THE PADDINGTON SOCIETY INC  
FOR COMMUNITY AND HERITAGE  
EST 1964

23 March 2026

**OBJECTION to SSD-80626208 – 8-10 New McLean Street, Edgecliff**

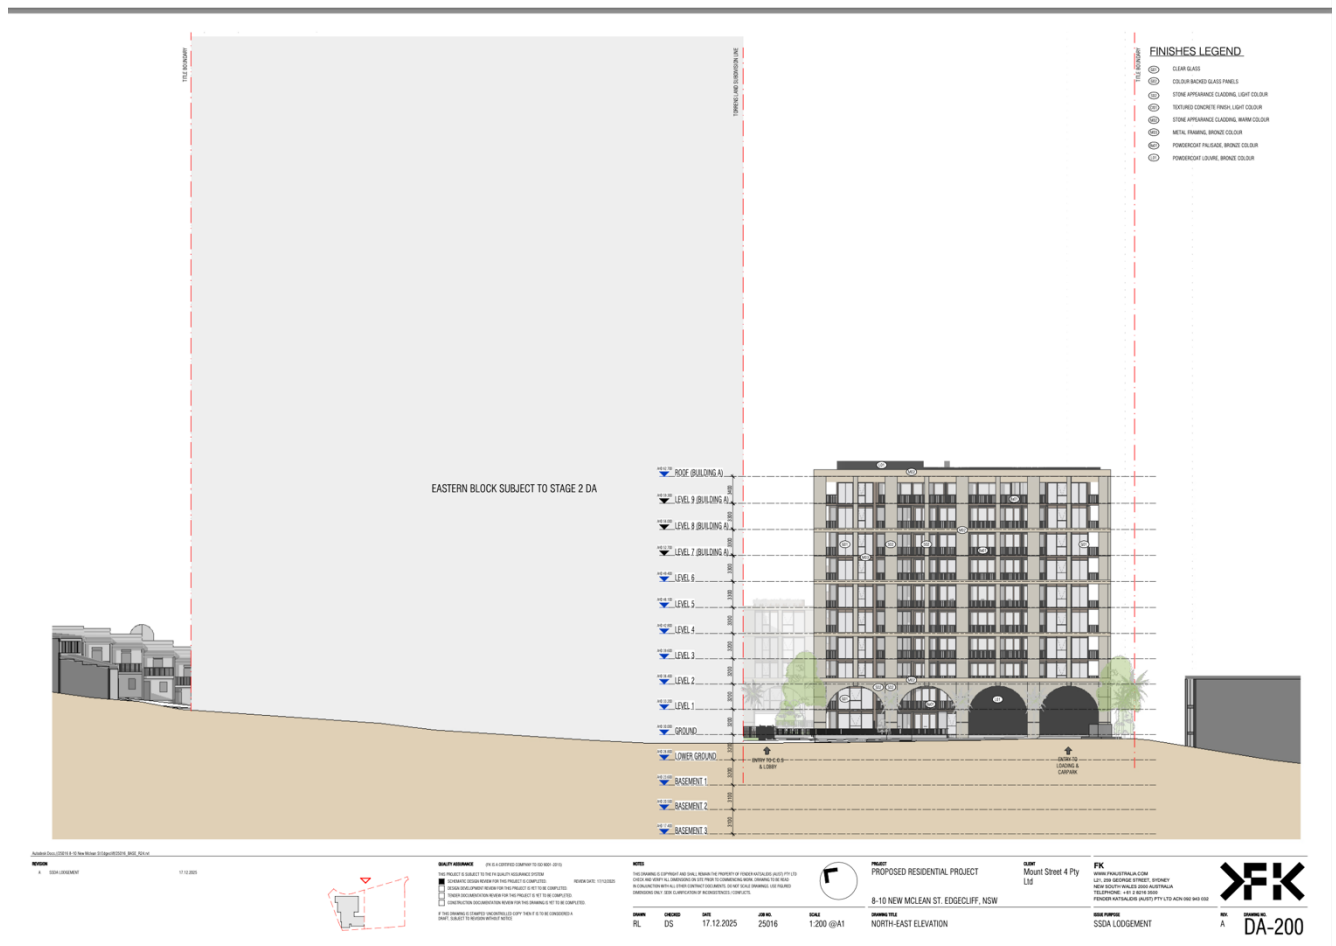
The proposed built form, height, bulk, scale and interface with the New McLean and Cameron Street dwellings and those in tiny Bowes Avenue to the south will be overwhelming and massively dominant.

- The architectural drawings indicate that the Stage 1 built form remains excessive and bulky in this context.
- Sited close to the curve of New McLean Street, with wide street level arched openings for vehicle access and egress and with a freestanding blank walled substation on the front boundary, there will be minimal scope for the narrow perimeter areas of landscaping designed for Stage 1 to screen and soften the presentation of the building to the street.

- At eight storeys greater in height and some twice the width of of Stage 1, the Stage 2 built form, if it ever eventuates, will be even more overwhelming; it will be highly visible from multiple locations to the north, east, west and from an extensive number of southern locations across Trumper park and oval and upwards in the catchment along the Paddington slopes towards Oxford Street.

**We note that the outlined bulk of the EASTERN BLOCK SUBJECT TO STAGE 2 DA on this and other elevations, as illustrated above, is significantly higher than that for the 18-storey bulk of the approved building envelope, and does not indicate the prescribed step-downs in RL towards the adjacent terrace houses in the HCA.**

**It appears to indicate the height and bulk of the former 25-storey proposal refused in 2024.**

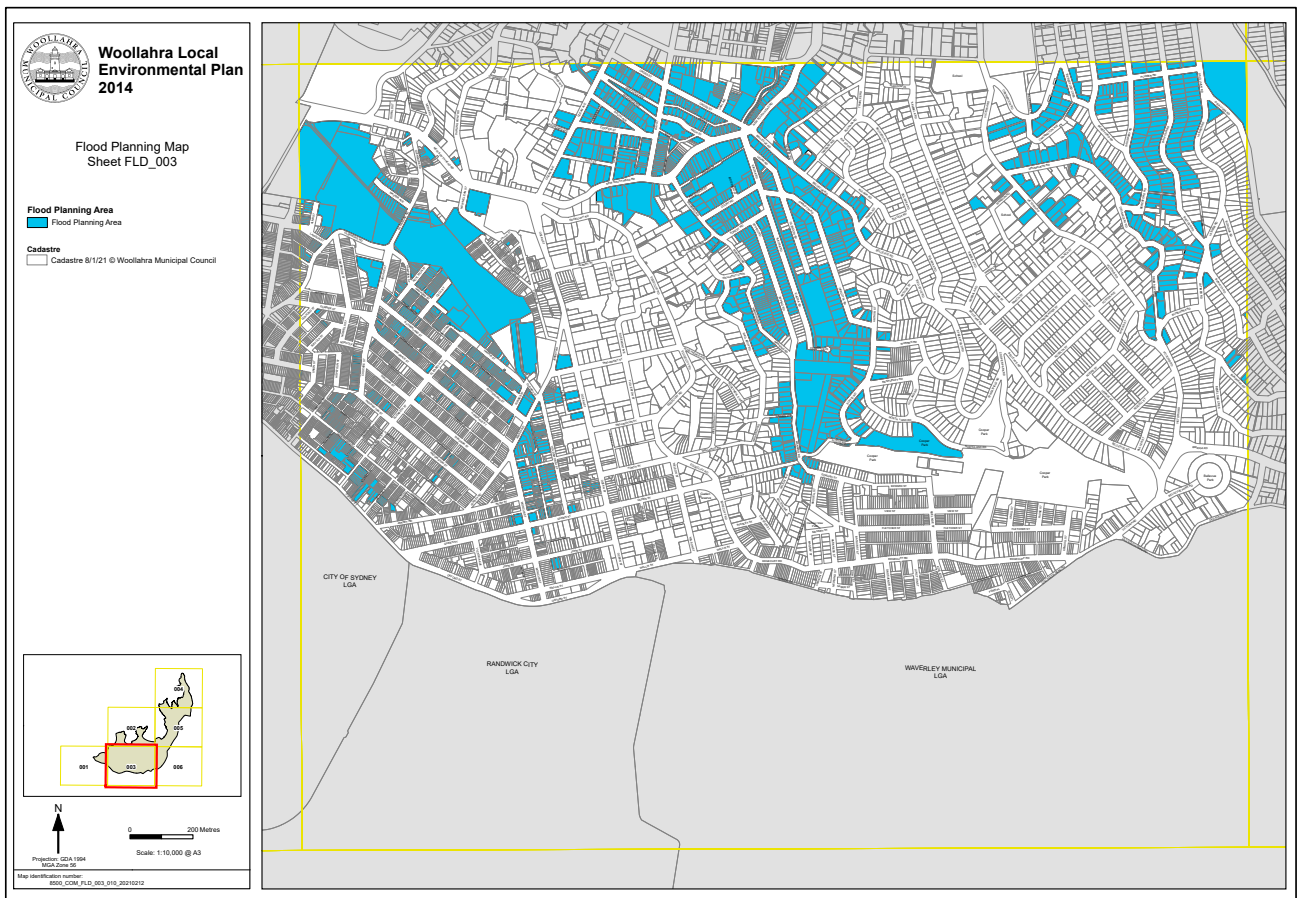
- Excavation will produce extensive material for disposal. For much of the 19c and well into the 1890s, the area directly to south of the site included thick scrubland on degraded sandstone outcrops, quarried to build villas, cottages, street boundary alignments and public buildings of the emerging suburb.
- Land to the south of the site was marked “Quarry Reserve for use of the Woollahra Municipality”. Quarried sandstone faces border the park, the area later became a dump for ash, and building waste.

- Much of the excavated material is likely to include contaminated materials. Parts of Hampden Park (later re-named Trumper Oval and Park) had to be filled up to four metres to form the Oval, with much of the contaminated material likely to remain in the fill.
- Residents in Cecil Street to the south of the park regularly report to Council about contamination, and we are aware that asbestos has been identified by WMC as being one of the contaminants in the park, downstream from the *whole* 8-10 New McLean Street site.
